ACKNOWLEDGMENT OF ADDENDUM #3

We do hereby acknowledge the information and/or changes described in
Addendum #3 to Request for Proposals 2025-006 Pinebrooke 5 Renovation Phase 1

Addendum No:	#1	Issue Date:	10/6/25
Project:	HCSO Training Academy Phase 1	To Drawings + Specifications dated	8/6/2025
Prepared By:	Harvard Jolly PBK 5201 W. Kennedy Blvd. Suite 515 Tampa, FL 33609		
PBK Project No:	23106

TRAINING ACADEMY - PHASE 1

M-400

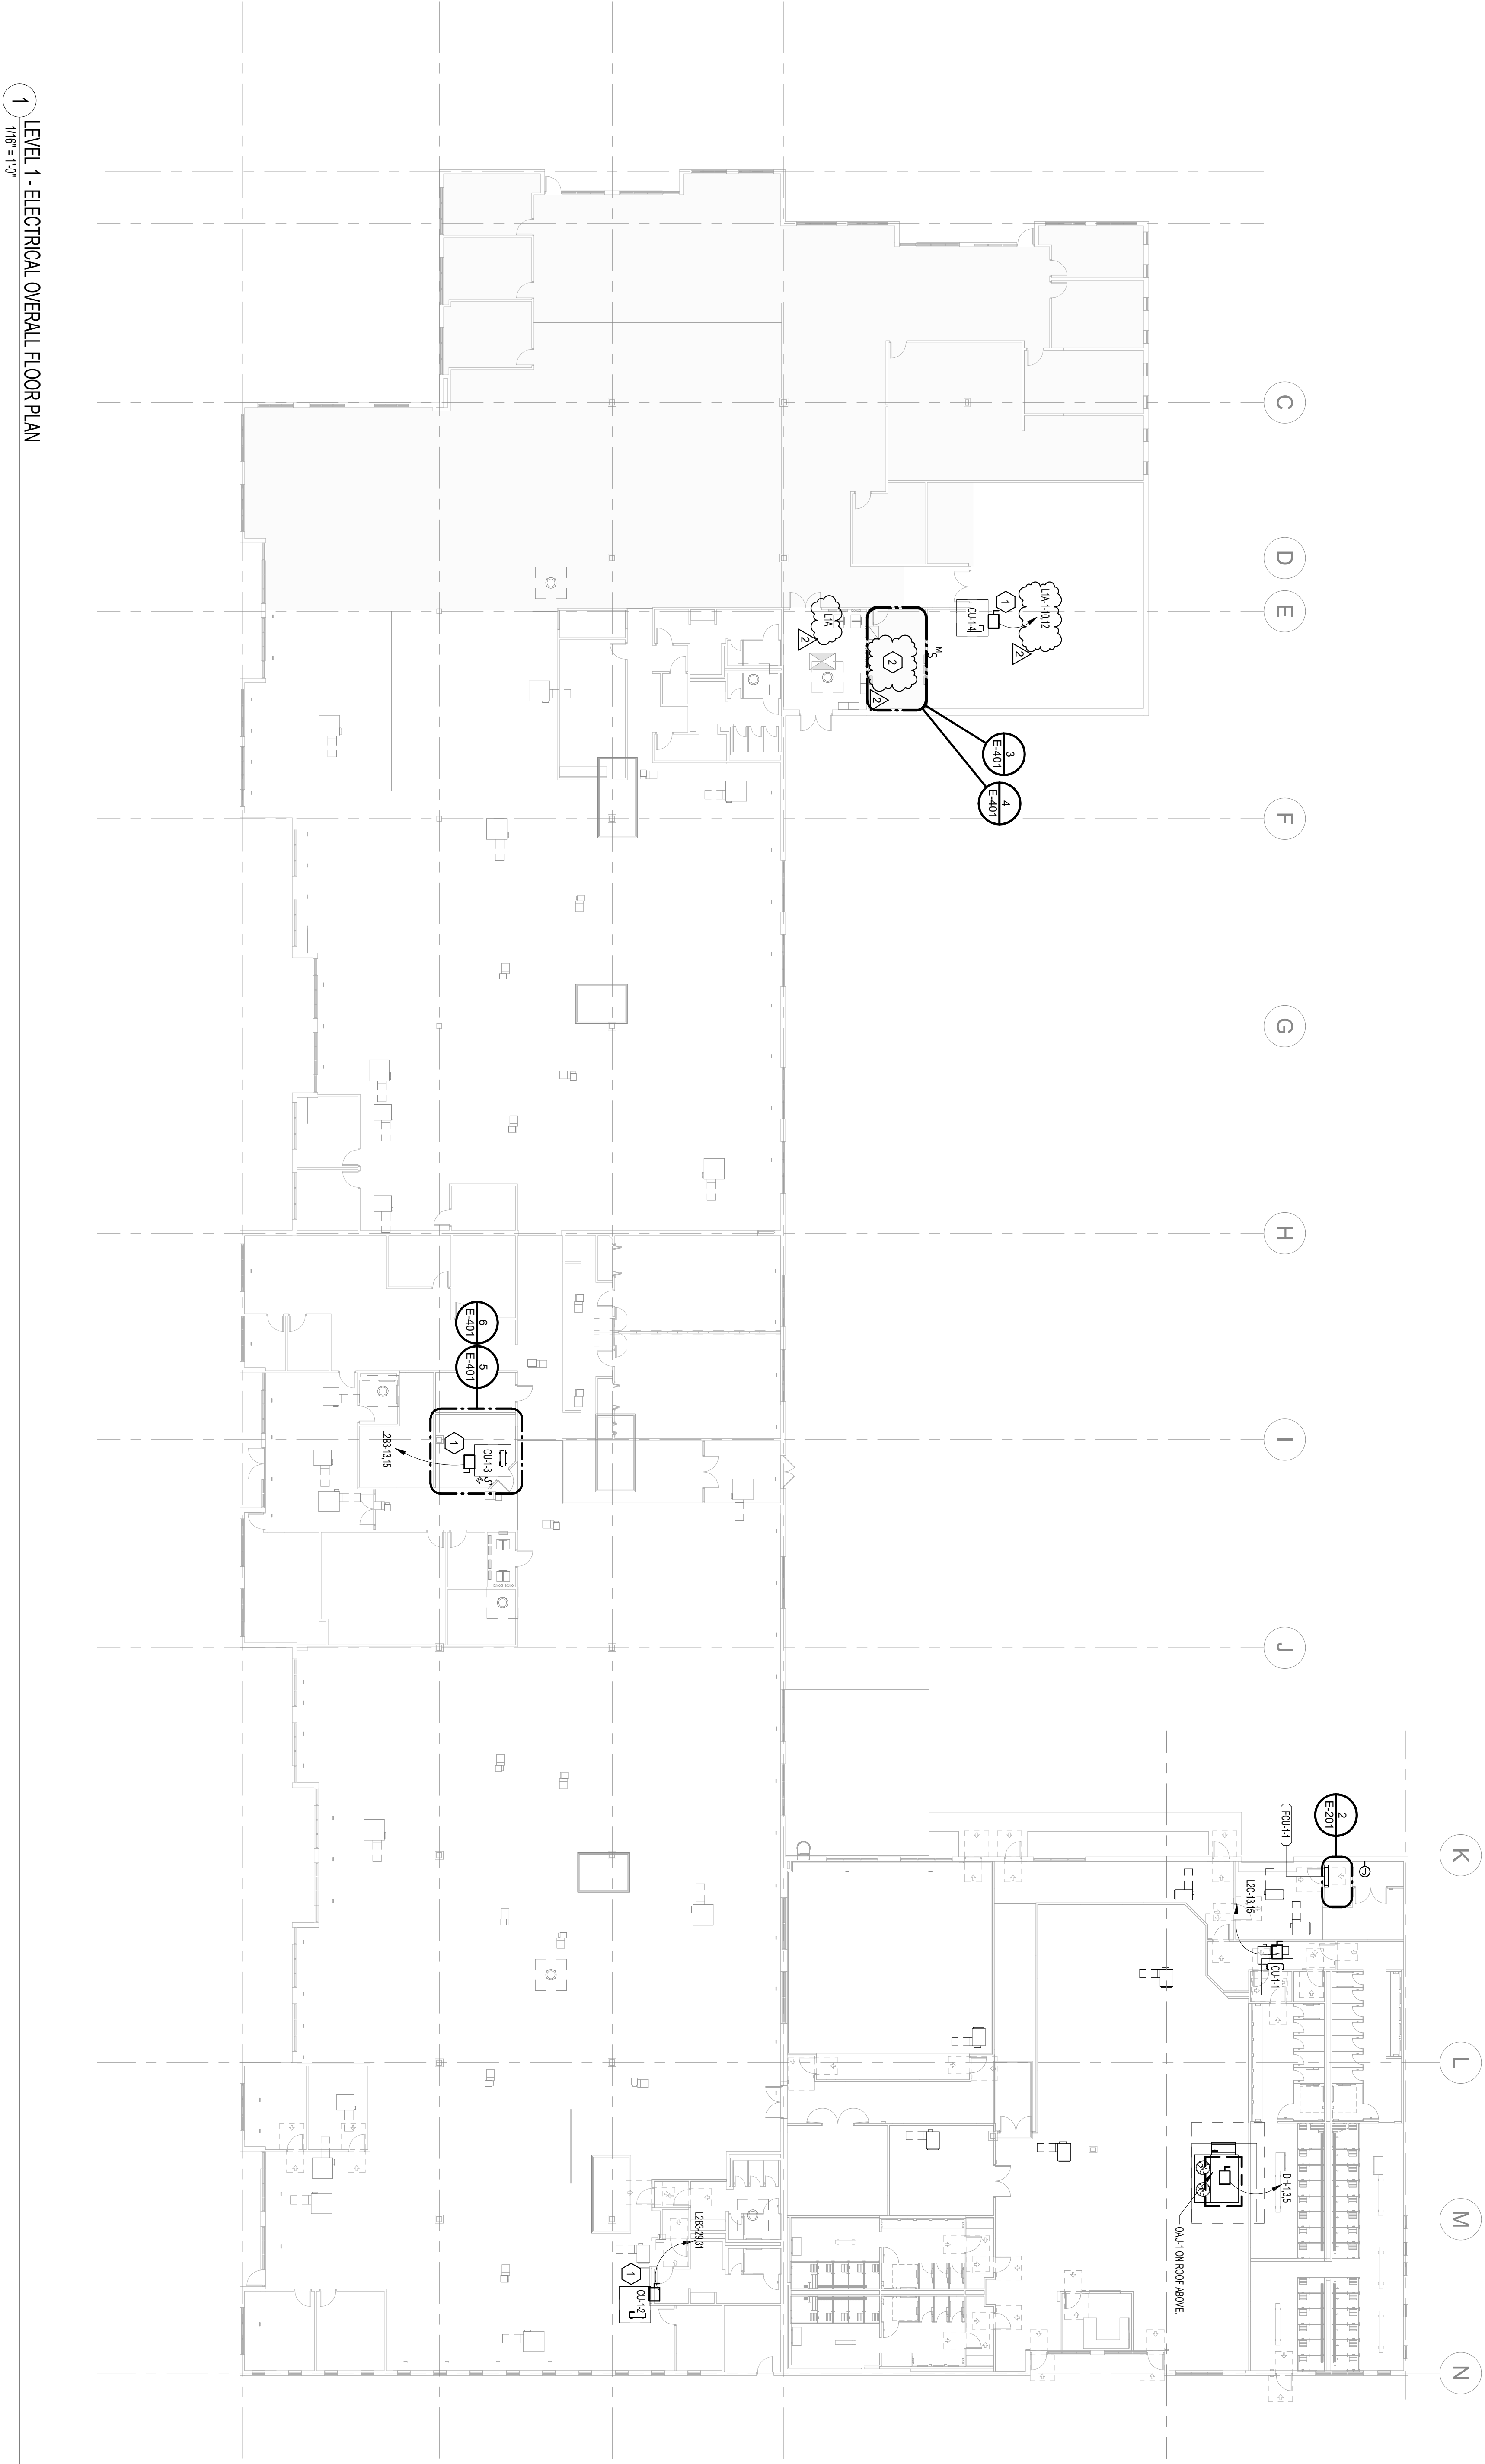
M-400: Revised IDF Room 118

E-202

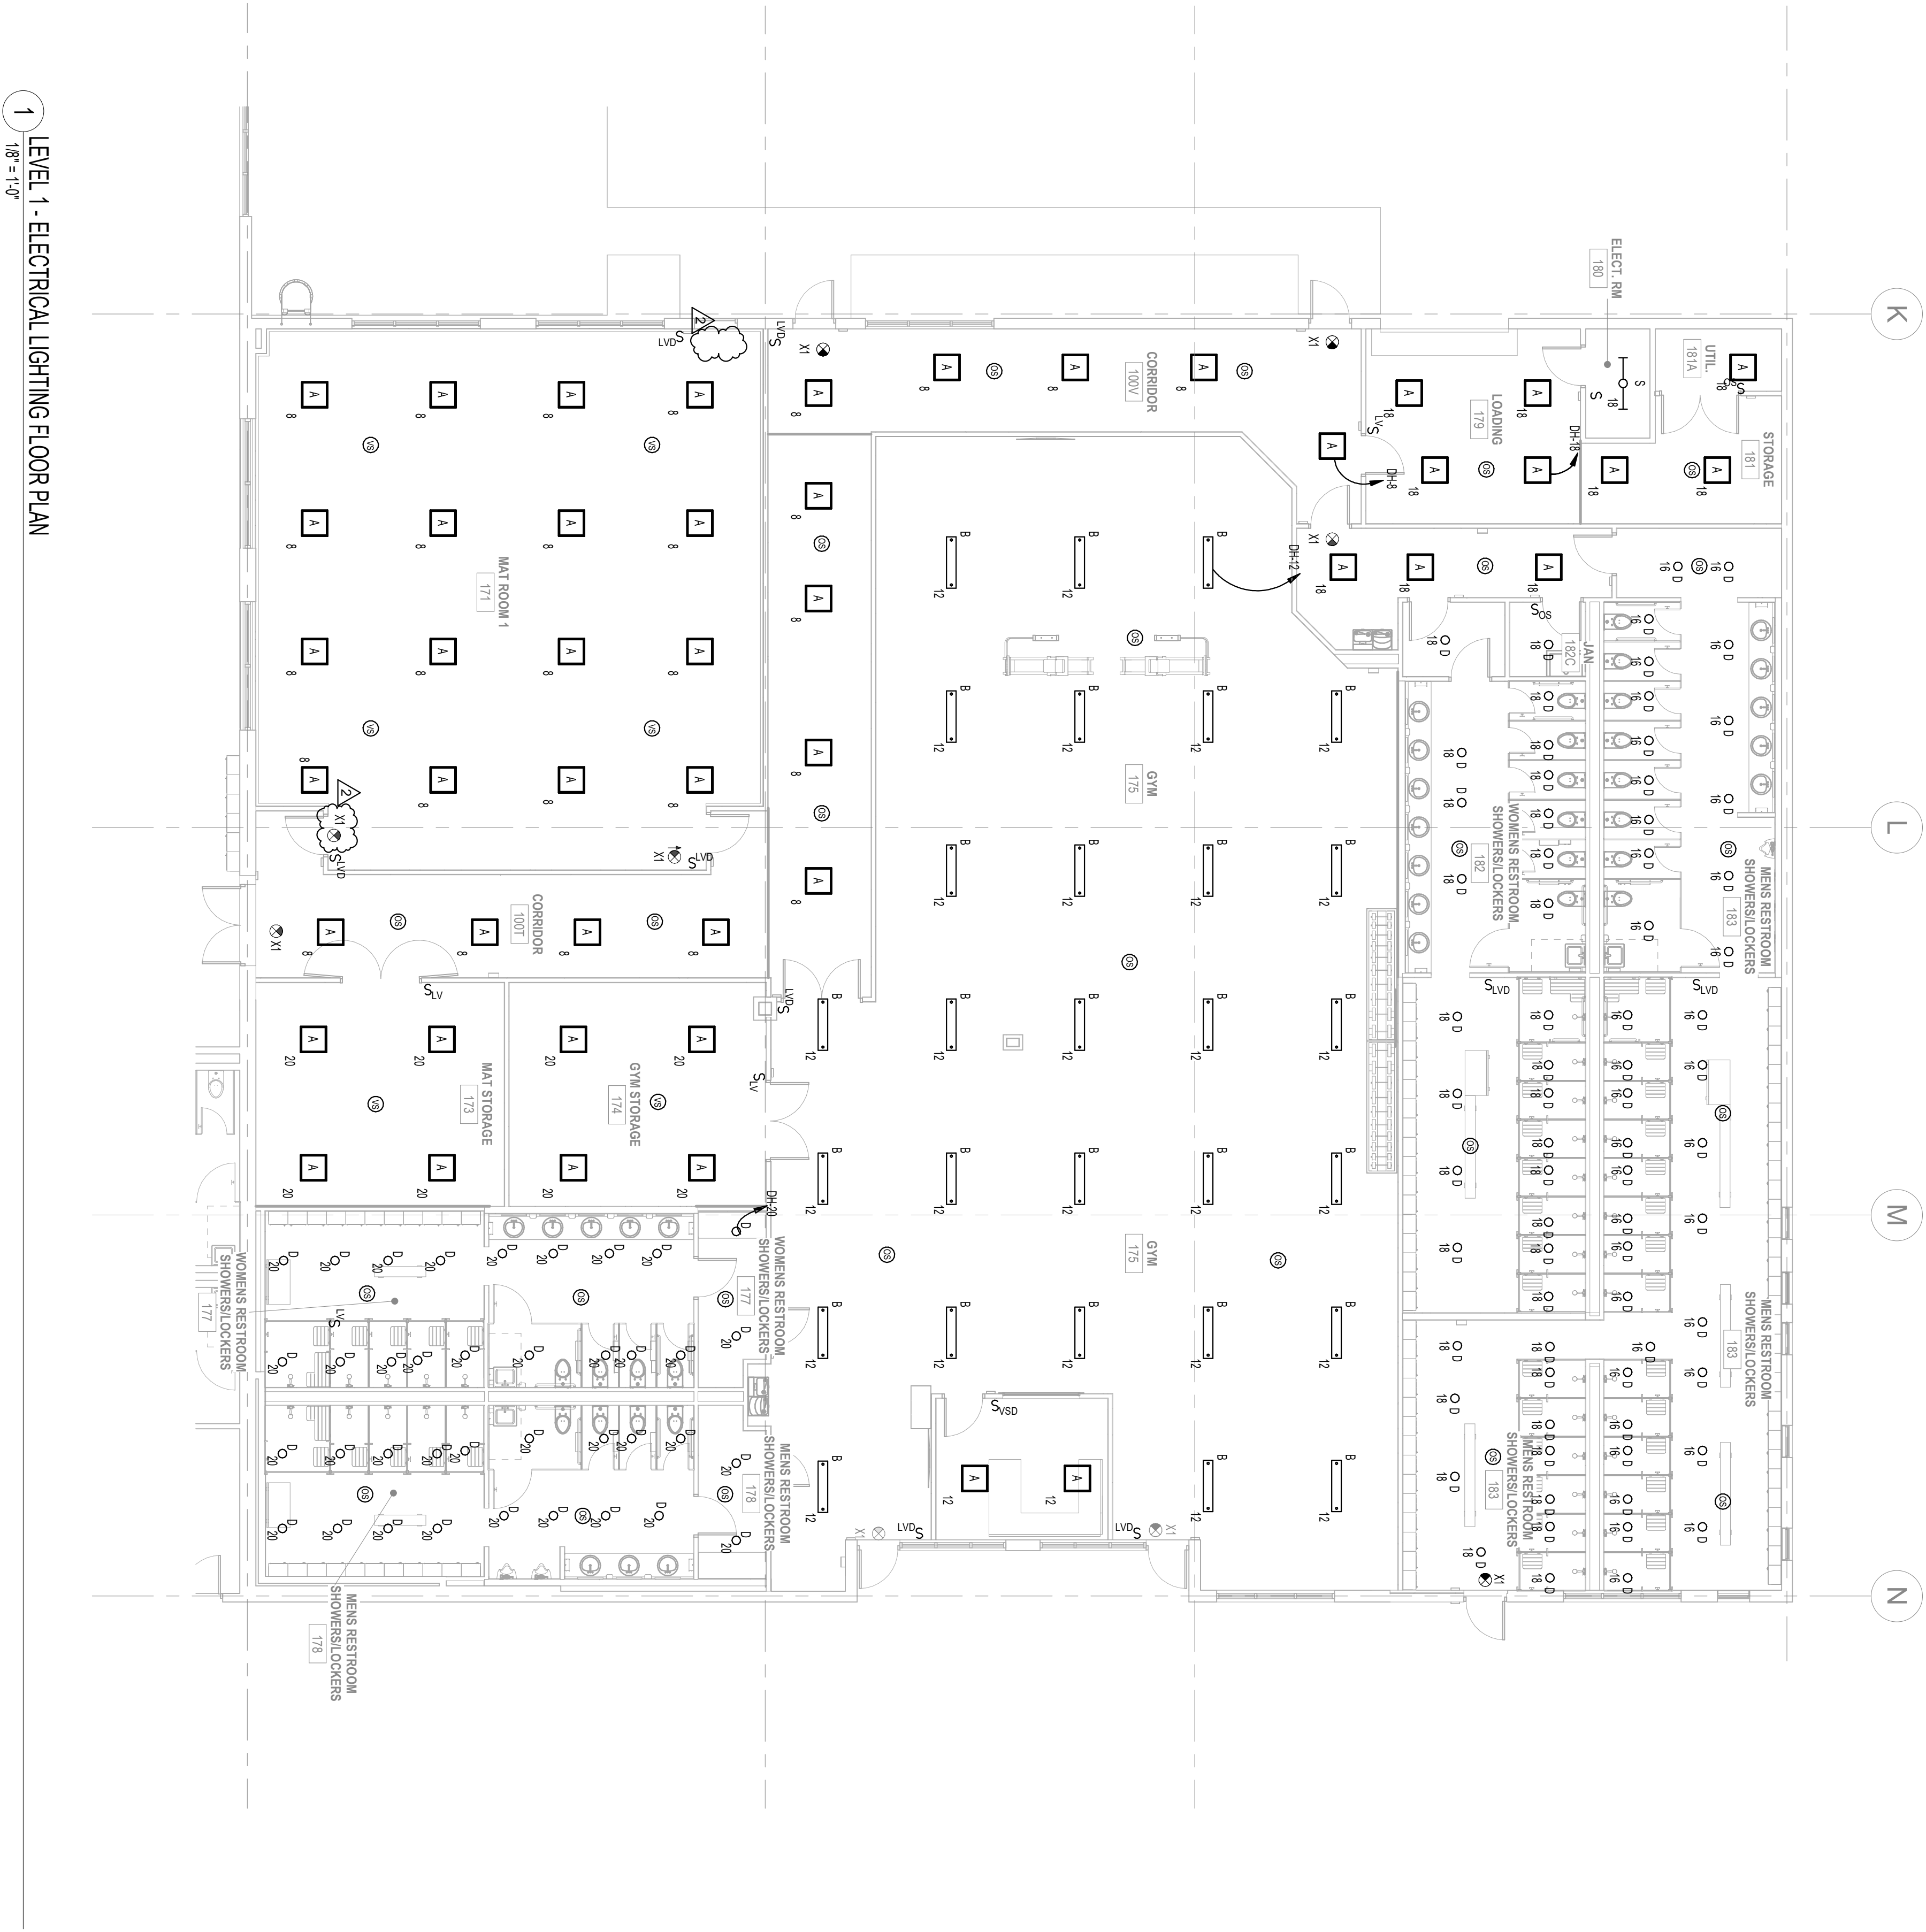
E-202: Revised locations of exit lights

E-401

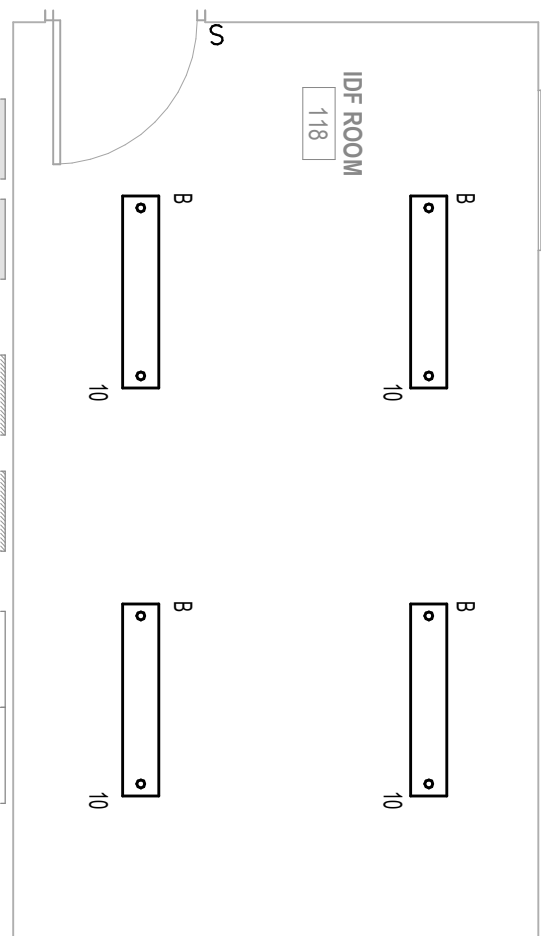
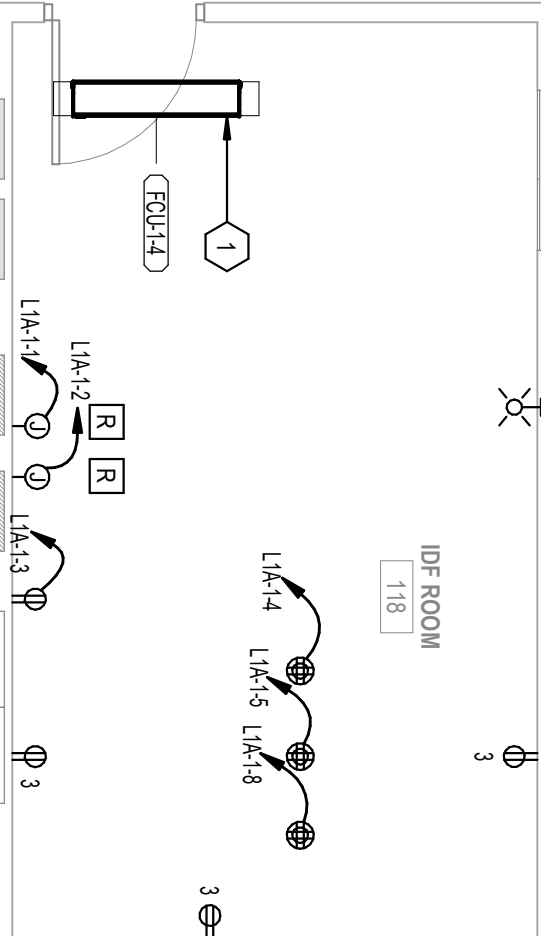
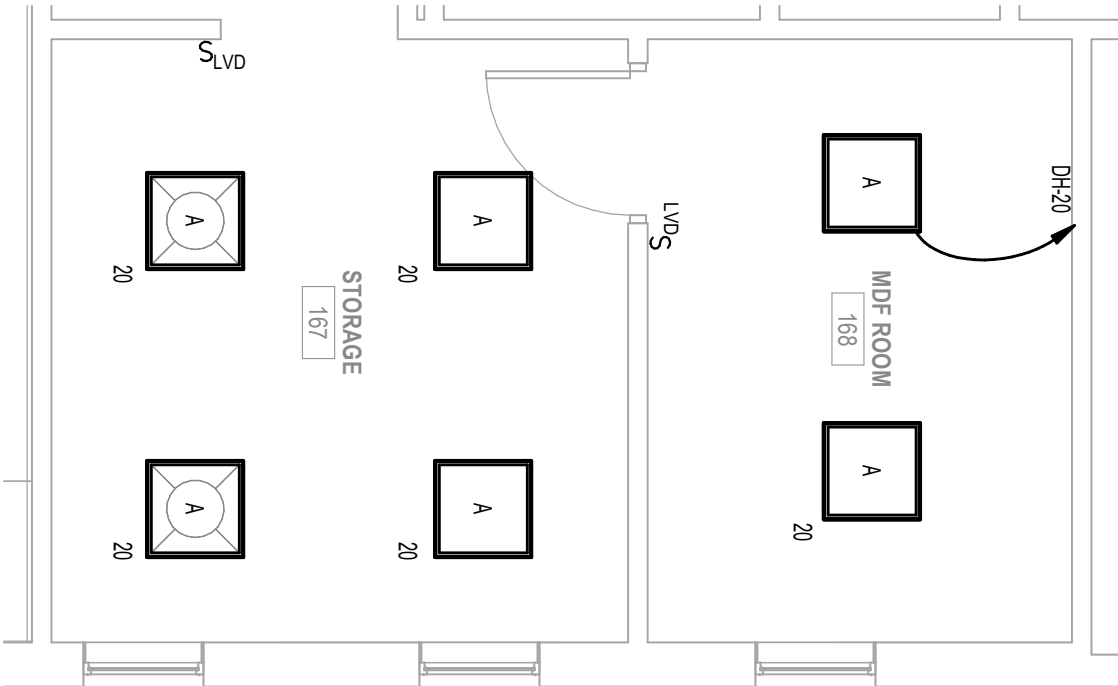
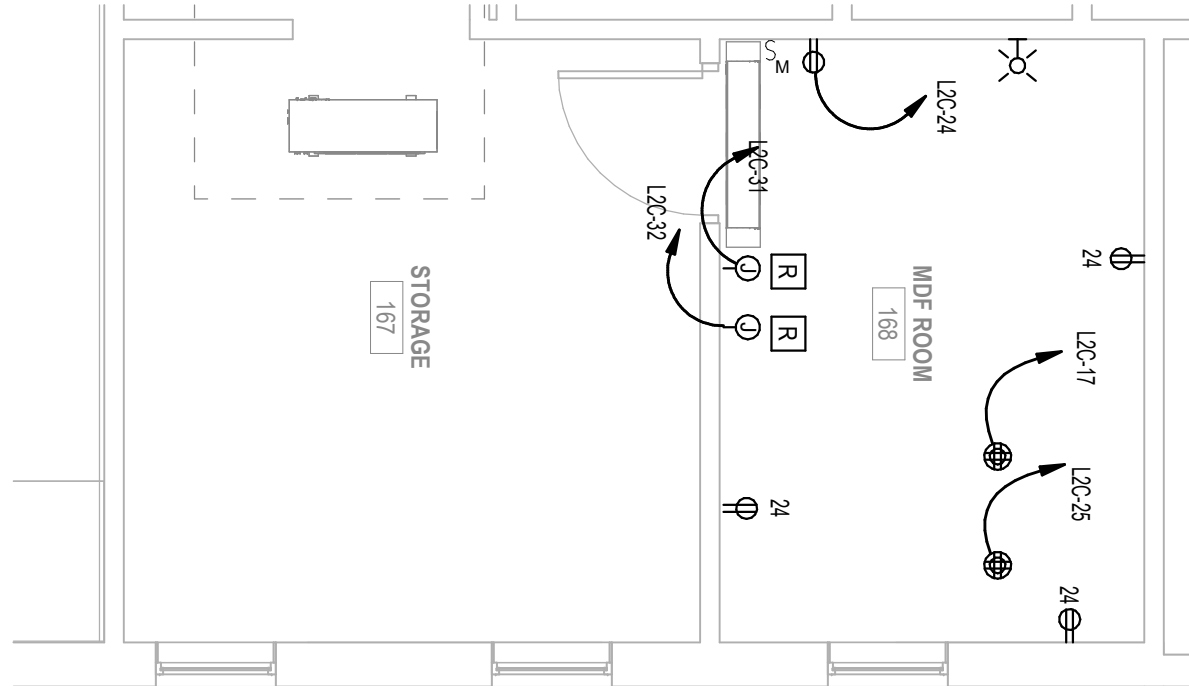
E-401: Revised IDF Room 118
E-501: Revised one line diagram
E-601: Revised panels L1A-1 and LUC
T-200: Revised IDF Room 118
T-401: Revised IDF Room 118
